Re: Second Submission Review: Green Valley Ranch East – Tibet Road Preliminary Plat – Minor Amendment 1
Case Number: 2021-6018-01

On behalf of Oakwood Homes and Terracina Design, we have reviewed the comments dated December, 23 2022. The following is a response to comments.

N. TIBET ROAD - TRIBUTARY T TO 48TH AVENUE INFRASTRUCTURE SITE PLAN

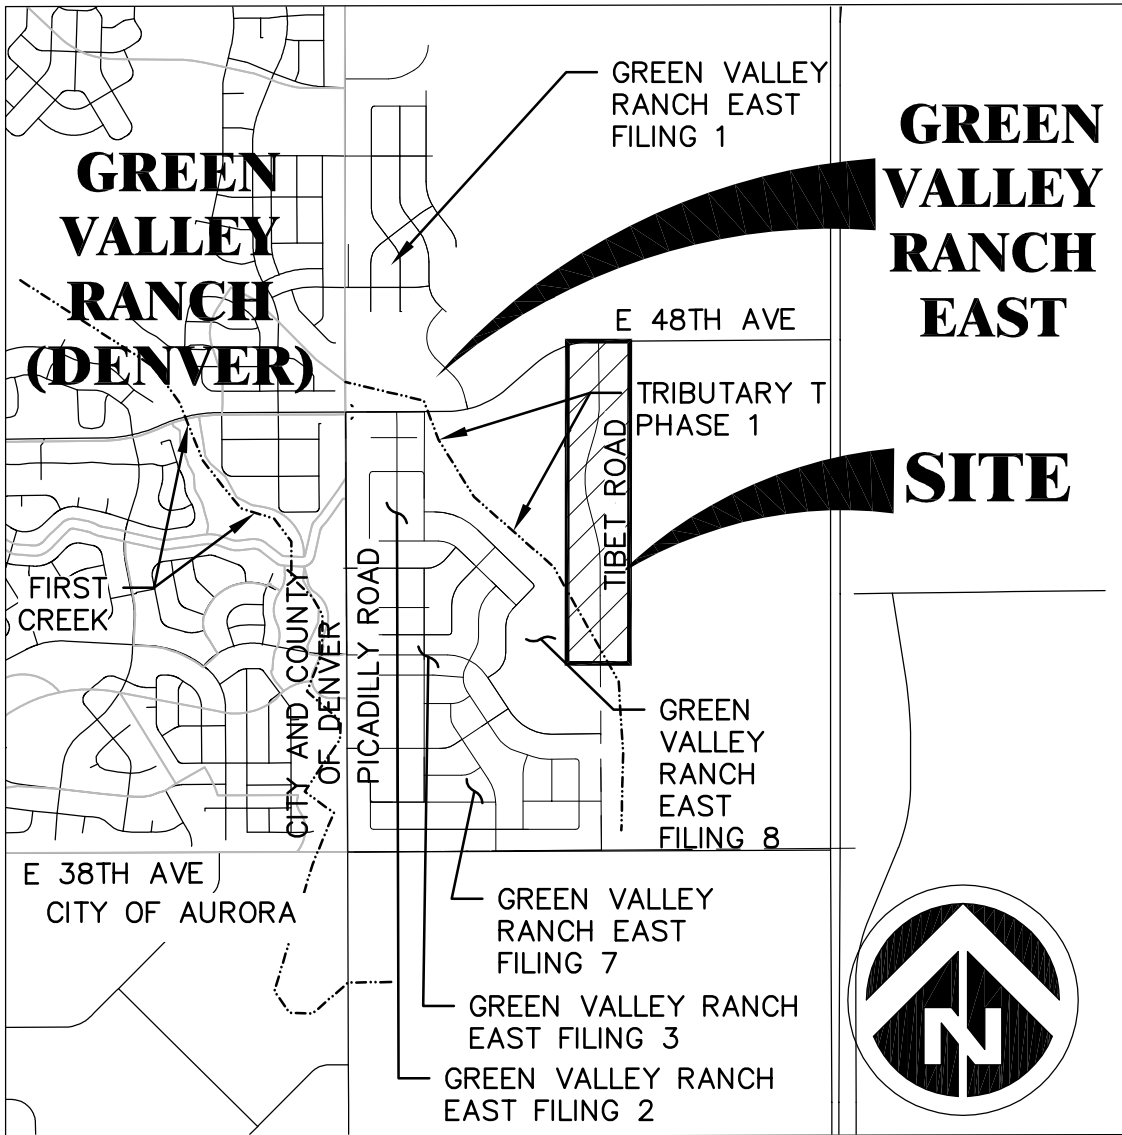
Civil plan revisions with a drainage letter have still not been submitted, nor has a preliminary drainage letter been submitted. This site plan amendment will not be approved until a PDL is approved or civil plan revisions with a final drainage letter are approved

Add red delta 1

DEWBERRY RESPONSE: A DRAINAGE LETTER HAS BEEN SUBMITTED, AND IS CURRENTLY UNDER REVIEW WITH THE CONSTRUCTION DOCUMENTS PACKAGE FOR THE PROJECT.

DEWBERRY RESPONSE:
THE RED DELTA BLOCK
HAS BEEN ADDED TO
THE PLANS.

DEWBERRY RESPONSE:
THE AMENDMENT
SUBMITTAL DATE HAS
BEEN REMOVED FROM
THE COVER SHEET.

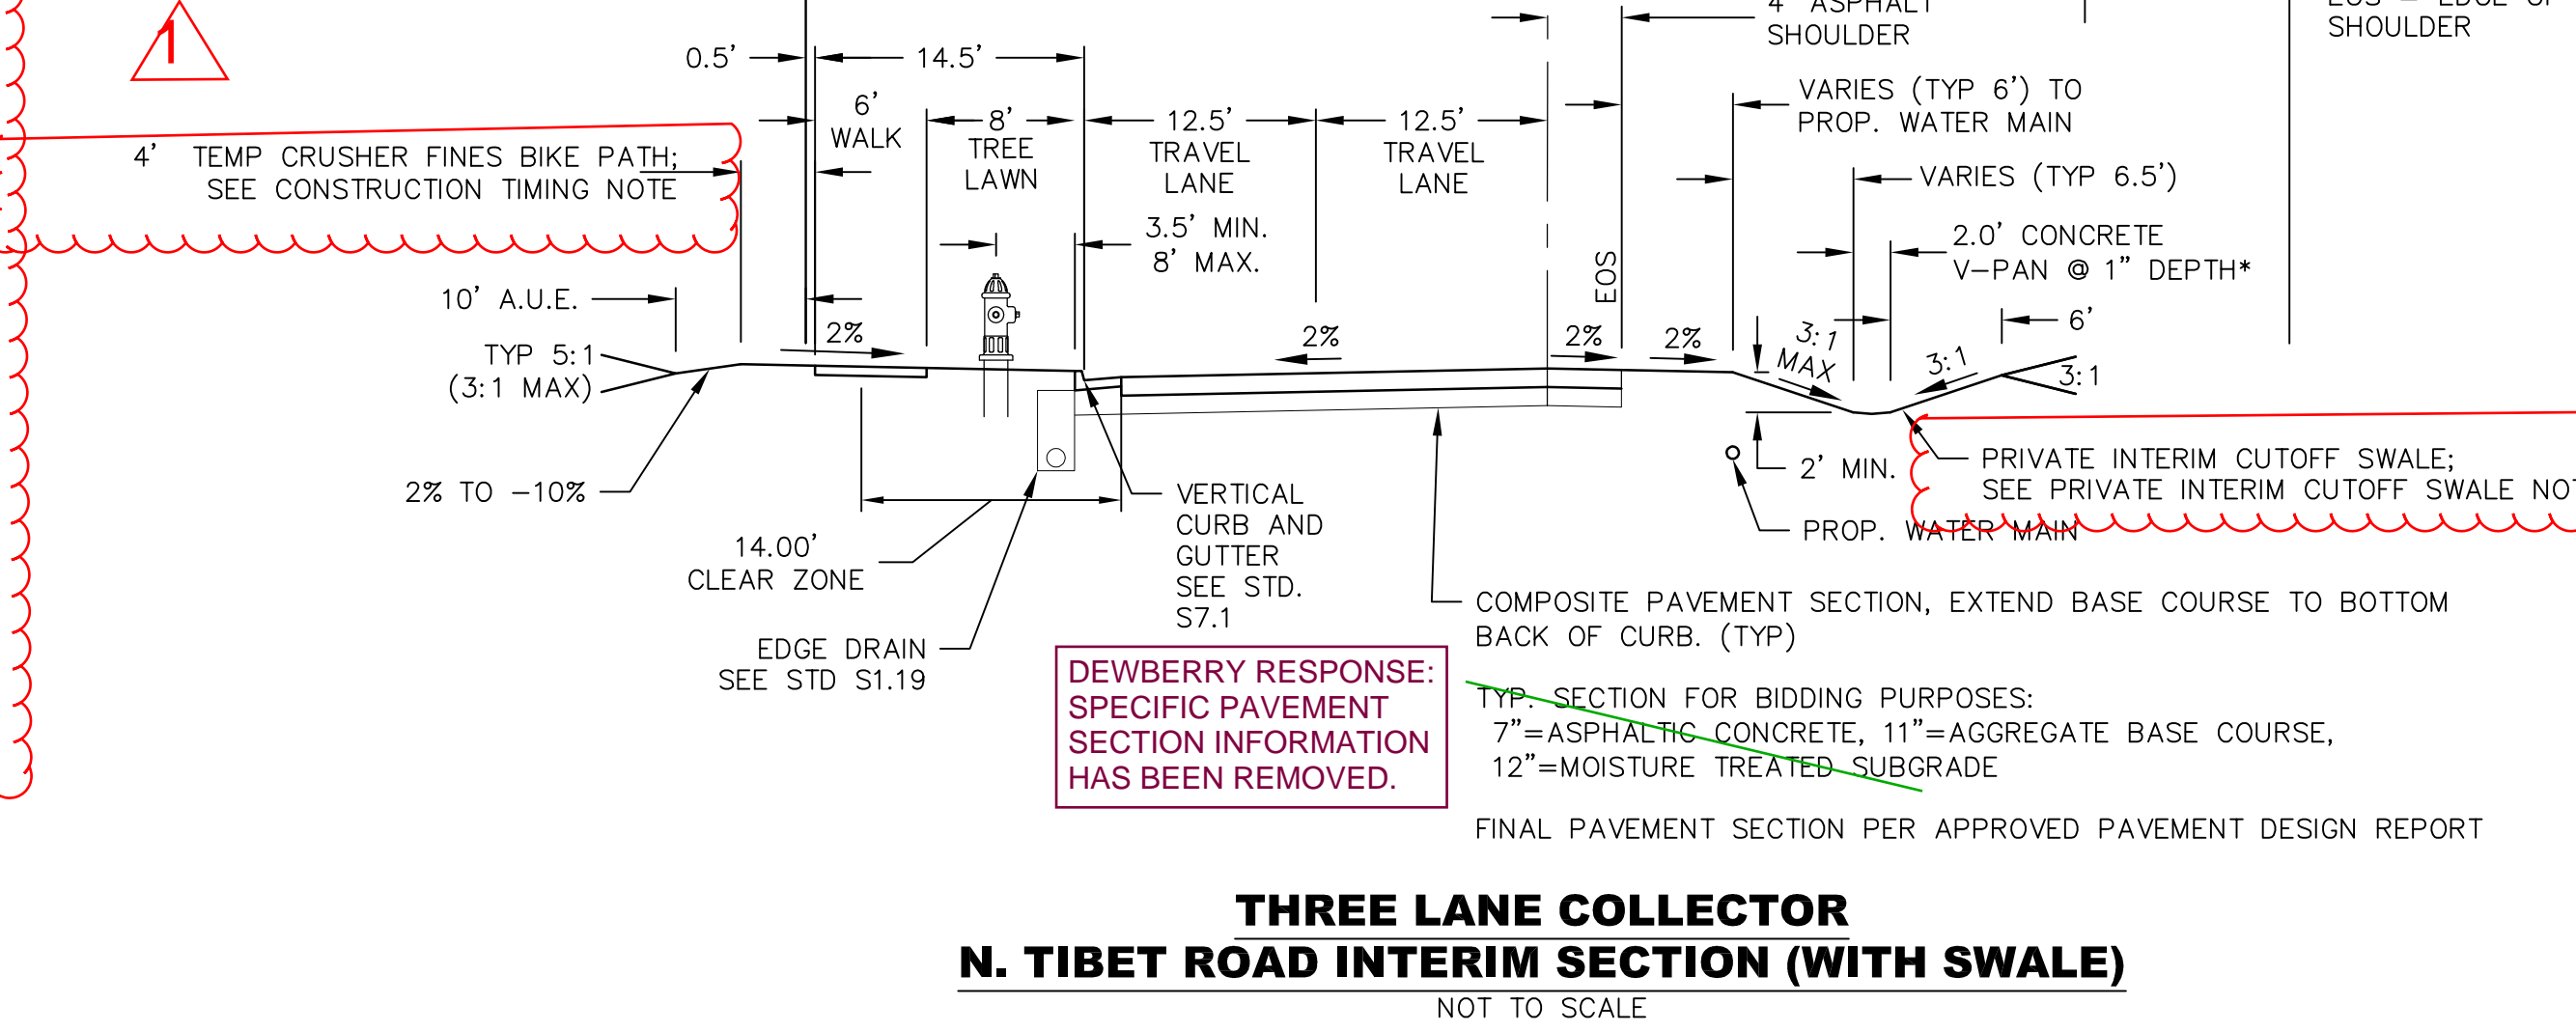
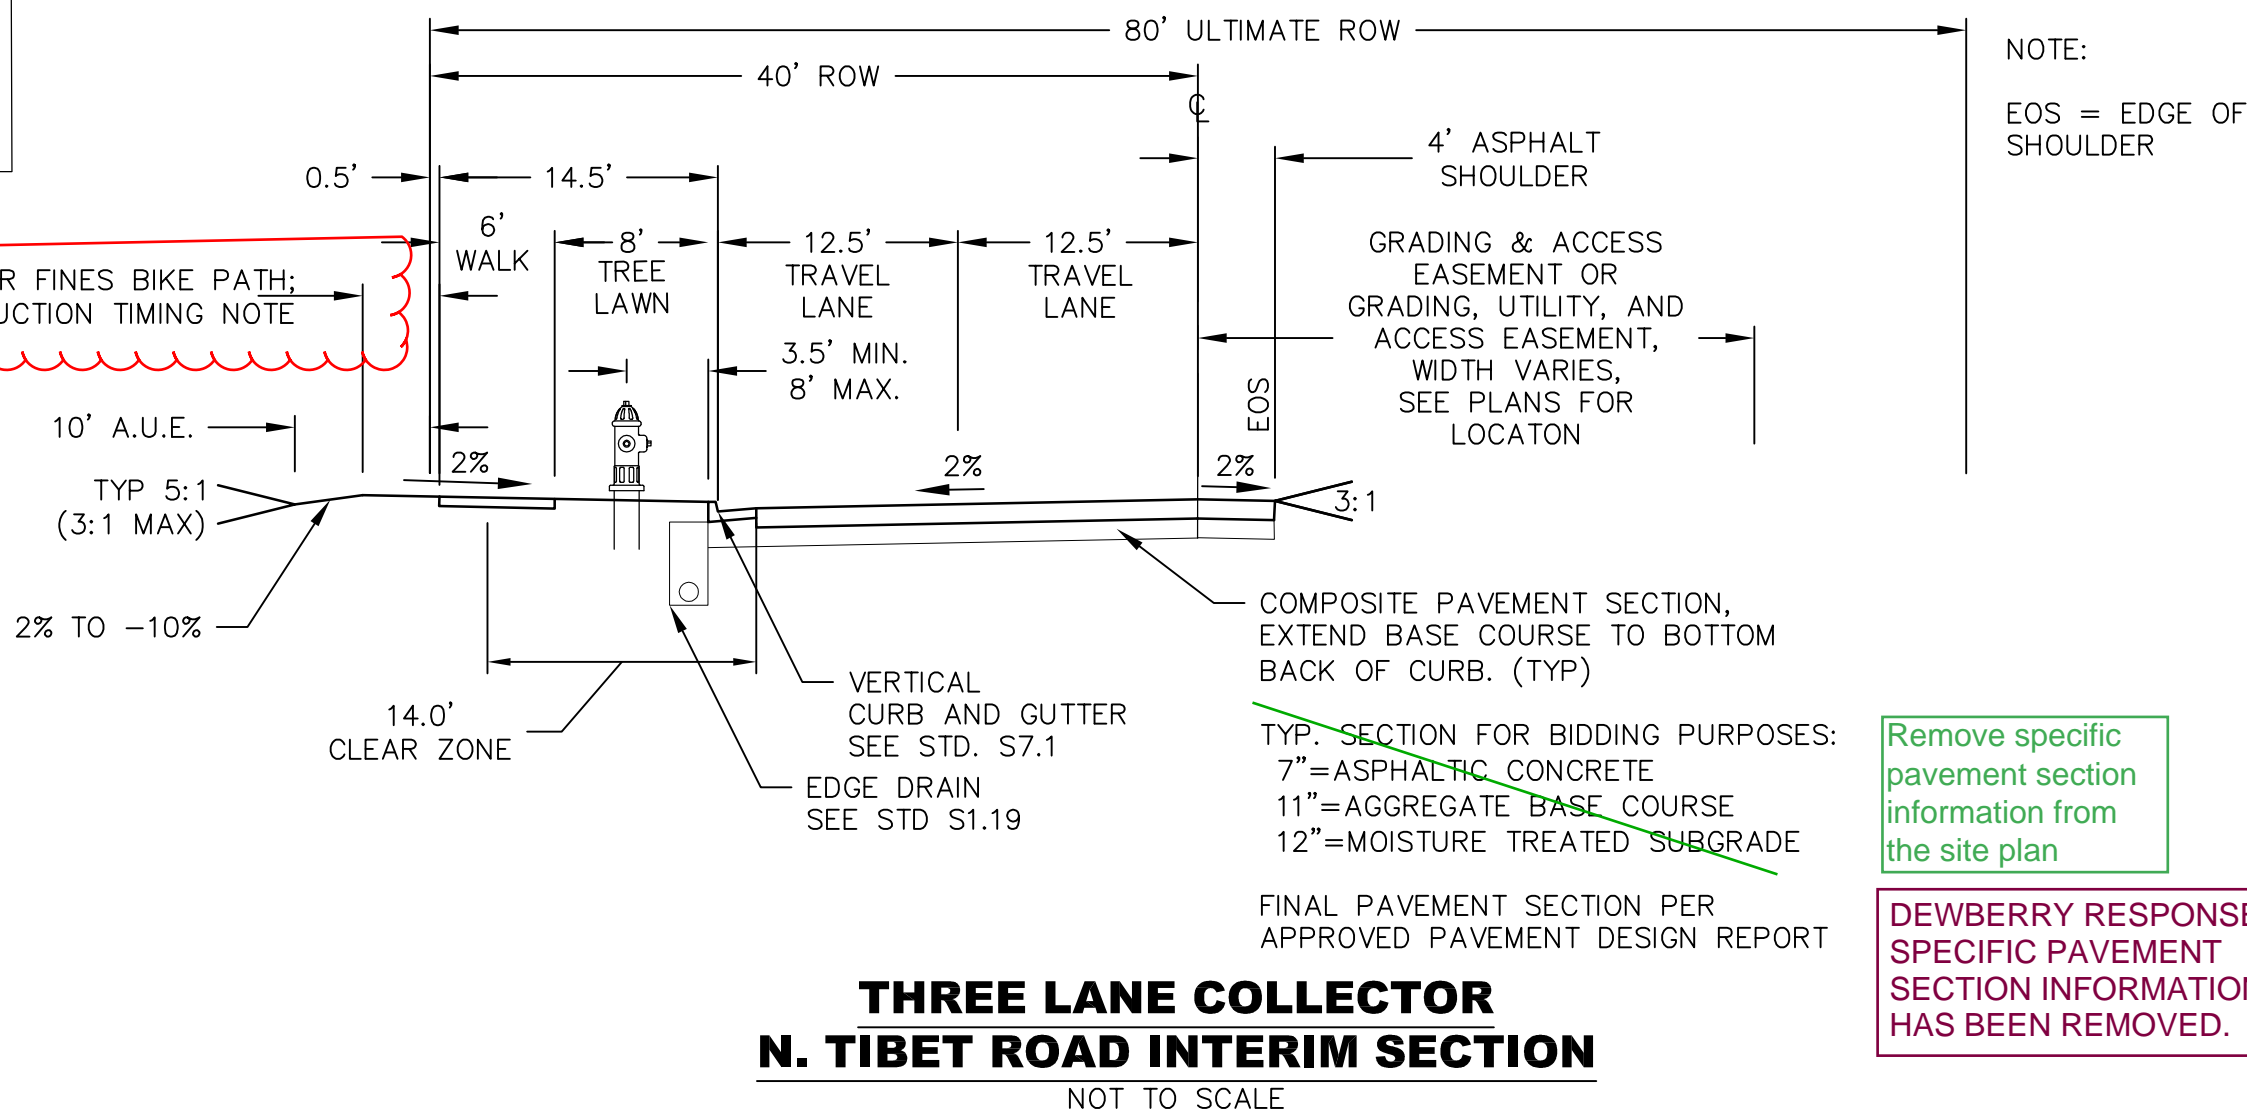
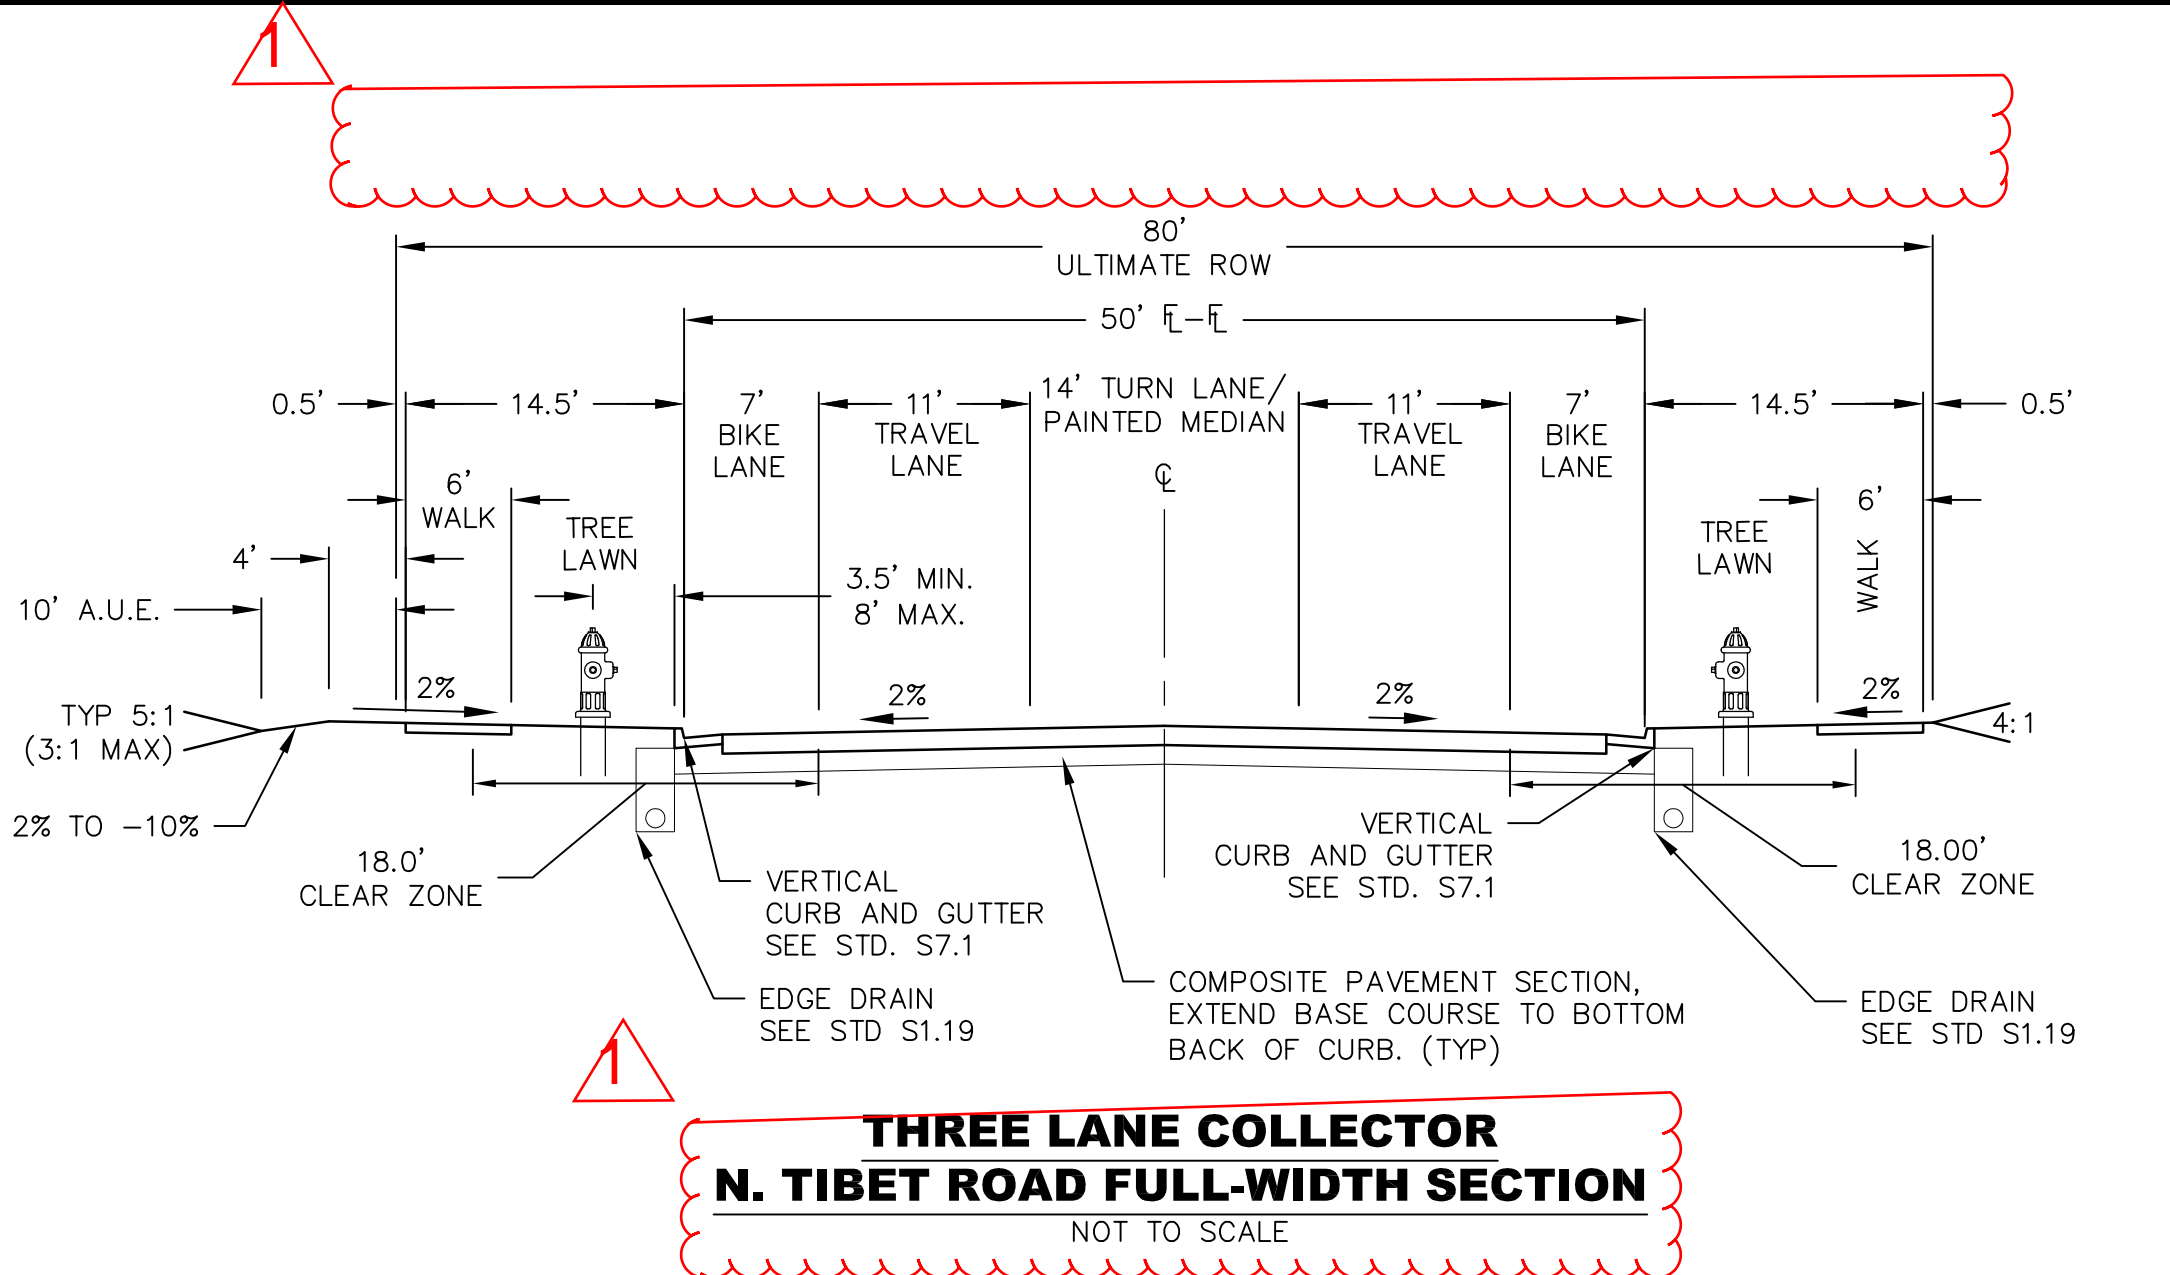
Add a cloud since this is a new note

DEWBERRY RESPONSE: THE NOTE HAS BEEN CLOUDDED.
